CHRYSLER 41TE (A604) CHECKBALL LOCATION CHANGES FOR THE 1995 MODEL YEAR

Figure 1

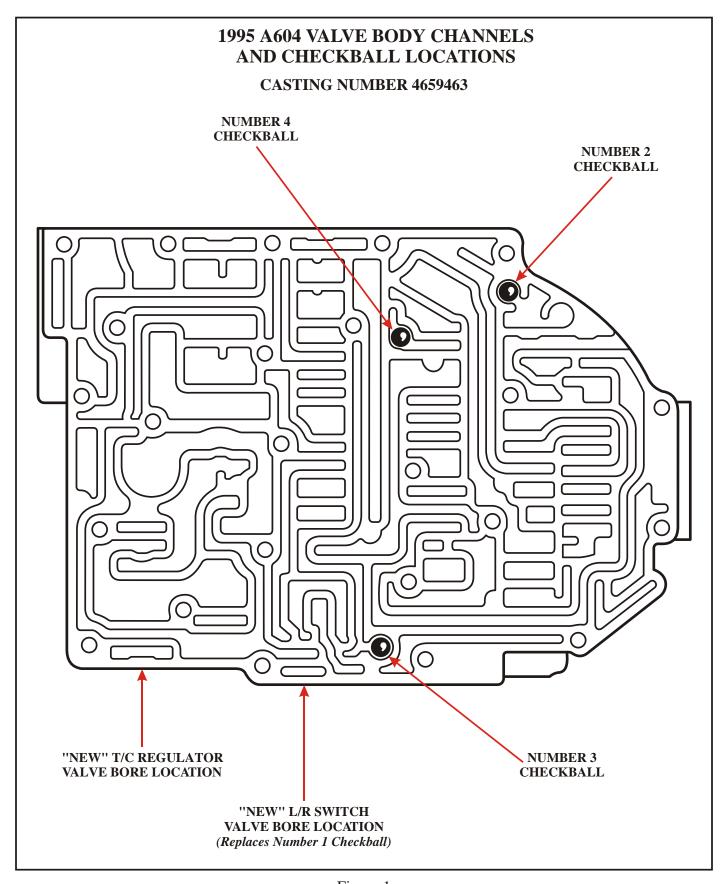
- (1) VALVE BODY New valve body casting with the Number 1 checkball eliminated, as shown in Figure 1. Two new valves were added to the valve body, first was a L/R Switch Valve to serve the same function as the number 1 checkball, and second was a T/C Regulator Valve to limit converter clutch apply pressure to a maximum of 95 PSI. Refer to Figure 1 for the locations of these new valves and the new checkball locations.
- (2) TRANSFER PLATE New transfer plate casting to accommodate the changes in the new design valve body. Refer to Figure 2 for the new transfer plate.
- (3) SPACER PLATE New spacer plate stamping to accommodate the changes in the new valve body, as shown in Figure 3.

Figure 2

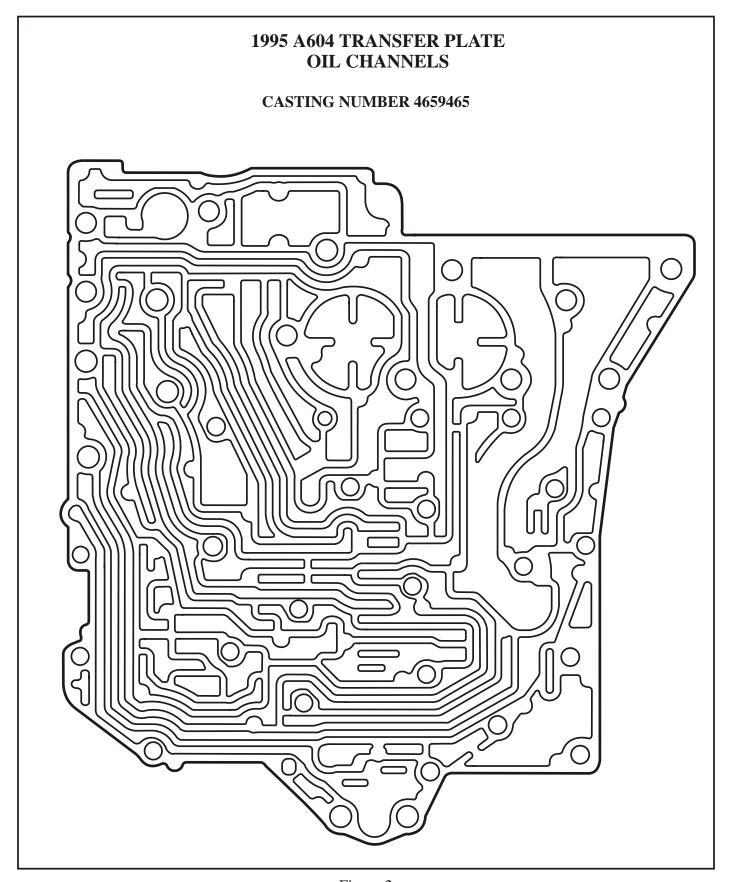
CHANGE: Beginning at the start of production for all 1995 models of the A604 transaxle, Chrysler made changes to the valve body that will affect service, and includes checkball changes in the valve body. Refer to Figures 1, 2, and 3.

Figure 3

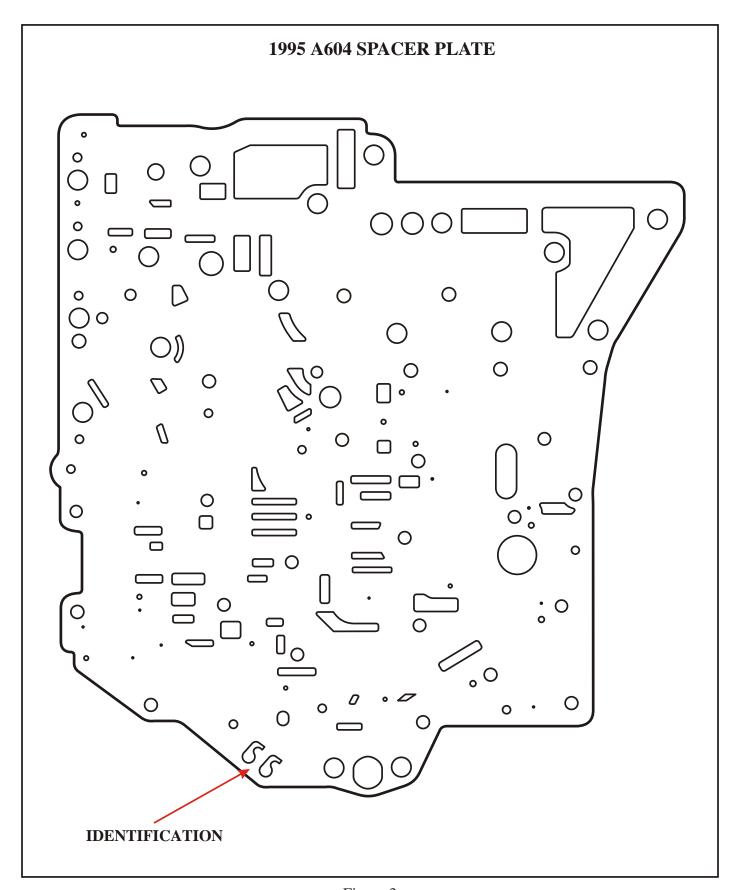
Number stamped for identification into new spacer plate is "66" (See Figure 3).
